5 SPARK PLUG MISFIRING (1956 8-Cylinder Engines)

Fig. 4 - Ignition Wire Relocation
(Item 5)

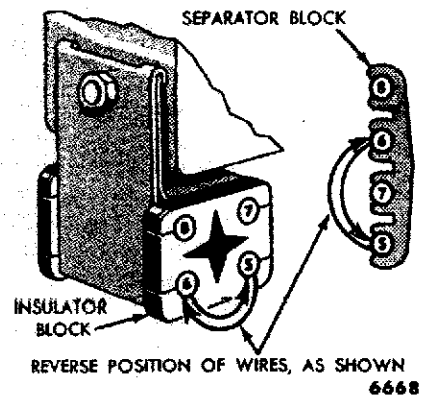
Occasional spark plug misfiring in 1956 8-cylinder engines can be caused by induction firing between the No. 6 and No. 8 cylinder spark plug wires. This condition can be corrected as follows:

Reverse the positions of No. 5 and No. 6 wires in the left-hand harness insulating blocks and separator blocks as shown in Fig. 4. This will increase the distance between the No. 6 and No. 8 wires and eliminate the induction firing.
